PRODUCT/PROCESS CHANGE NOTIFICATION

PCN APM/08/3892 Notification Date 07/31/2008

HCMOS4 TECHNO FAMILY PROCESS DIFFUSION TRANSFER FROM CARROLLTON 6" TO ANG MO KIO 6"

Generic ST Standard label

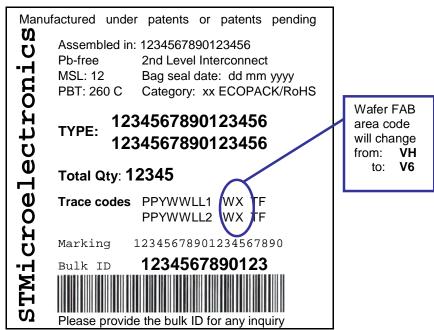
Unless otherwise stated by customer specific requirement, new parts produced in AMK6 will be differentiated as indicated below:

Diffusion plant	ID	Country of origin
Carrollton (current)	VH	USA
AMK6 (new)	V6	Singapore

Shipments from new Wafer FAB location will be tracked on the ST Standard Label as showed below:
